A.07-06-031 ALJ/VSK/tcg

CPUC CEQA Findings of Fact

Regarding the Final Environmental Impact Report for the
Tehachapi Renewable Transmission Project
State Clearinghouse #2007081156

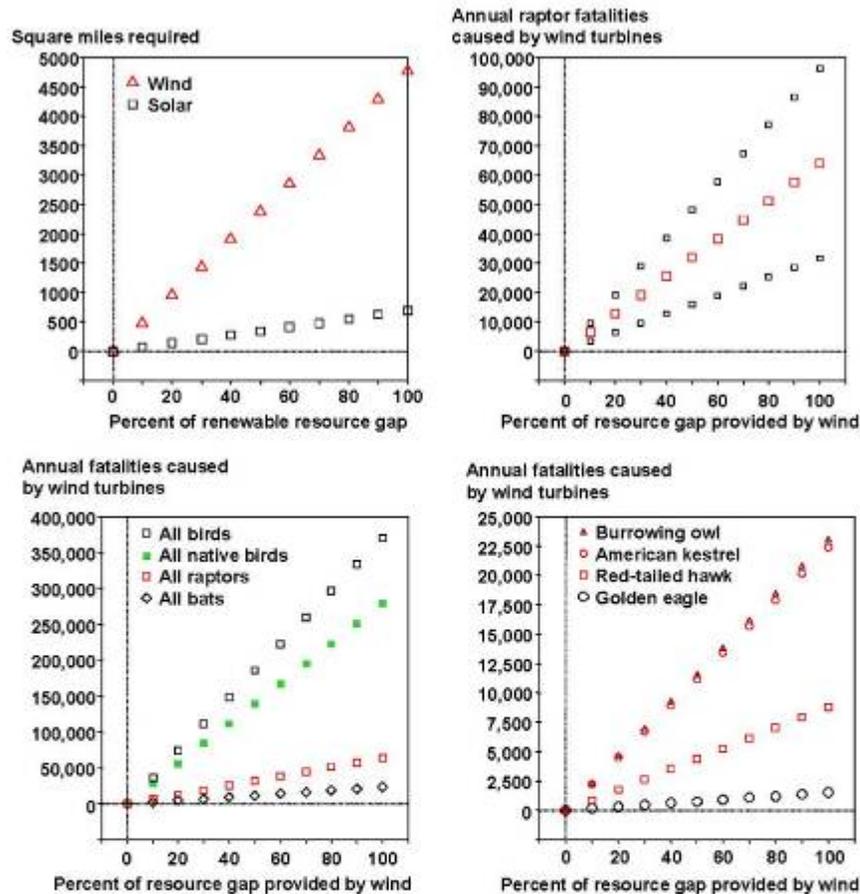
In terms of the space required to achieve the 33% RPS goal, solar energy generation would destroy a much smaller habitat area than would wind energy generation, and has the capacity on rooftops, blacktops, and disturbed areas to potentially cause no harm to habitats (Table 7, Figure 1). If only solar energy was pursued, and if it was all solar farms instead of near and within load

- B.21-57 Thank you for Figure 1, which illustrates the commenter's estimates of square miles required and annual fatalities of various species in relation to the percent of the resource gap provided by wind energy. However, as discussed in the response to Comment B.21-7, above, it is beyond the scope of this document to analyze the effects of meeting the 33 percent RPS using various types of energy generation.

Figure 2.2-2 (Revised)
Segment 4 ROW Cross-Section
(S4 MP 0.0 to S4 MP 5.1)

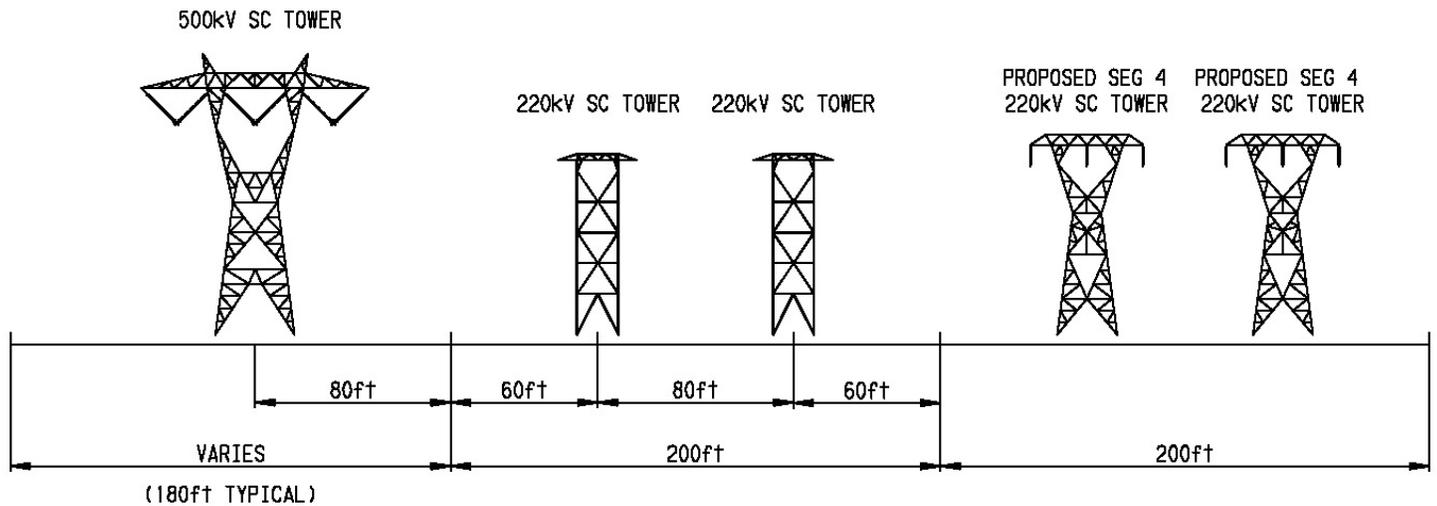
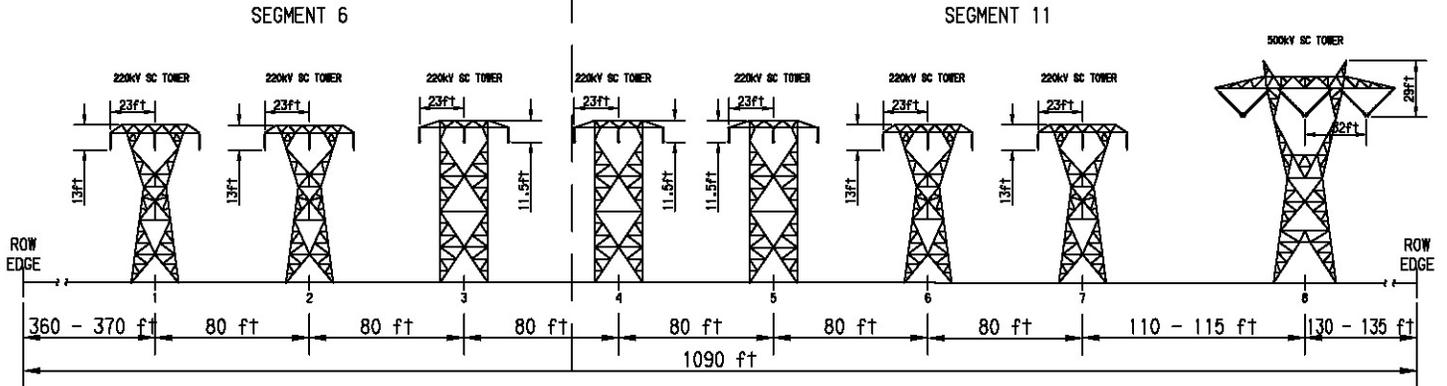
Figure 2.2-2		See updated Figure 2.2-2
Figures 2-10, 2.2-56, 2.2-57, 2.2-58	Figures 2.2-10, 2.2-56, 2.2-57, and 2.2-58 show cross sections from Segment 11 MP 0.0 to 4.0. In these cross sections under Future ROW the 500kV SC Delta Tower is shown as a triangular configuration on the top Insulator portion of the Tower.	Figures 2.2-10, 2.2-56, 2.2-57, and 2.2-58 have been updated to show a 500 kV double-circuit tower that has cross arms on one side. (See attached Figures 2.2-10, 2.2-56, 57, and 58).
Section 3.4 - Biological Resources		
Page 3.4-170 (Mitigation Measure B-8a, <i>Conduct protocol surveys for California red-legged frogs and implement avoidance measures,</i> Second Bullet)	<ul style="list-style-type: none"> • All trash that may attract predators of the red-legged frogs will be removed from work sites or completely secured at the end of each work day. At the Project crossing near the newly discovered population in Aliso Canyon, and anywhere California red-legged frogs are detected in or adjacent to the Project, the following shall apply: <ul style="list-style-type: none"> • A full-time monitor shall be present at the access road crossing near the newly discovered population of California red-legged frog in Aliso Canyon, while water is present. • Between 1 November and 31 March, no work will be authorized within one mile of occupied habitat and no vehicular crossings at wet fords of those channels will be authorized. The one-mile buffer distance may be reduced based on the topography of the site with the approval of the FWS, FS, and CPUC. • Between April 1 to 31 October, no work will be authorized within 500 feet of occupied habitat and no vehicular crossings at wet fords of those channels will be authorized. 	<ul style="list-style-type: none"> • All trash that may attract predators of the red-legged frogs will be removed from work sites or completely secured at the end of each work day. At the Project crossing near <u>near the newly discovered population</u> in Aliso Canyon, and anywhere California red-legged frogs are detected in or adjacent to the Project, the following shall apply: <ul style="list-style-type: none"> • A full-time monitor shall be present at the access road crossing <u>when in use</u> near the newly discovered population of California red-legged frog in Aliso Canyon, while water is present. <u>Use of the road will be restricted to daylight hours, except during an emergency, in order to avoid nighttime activities when red-legged frogs may be present on the access road. Traffic speed shall be maintained at 15 mph or less in the work area. Use of this roadway during rain events shall not occur during the activity period for California red-legged frogs.</u> • Between 1 November and 31 March, no work will be authorized within one 0.5 miles of occupied habitat and no vehicular crossings at wet fords of those
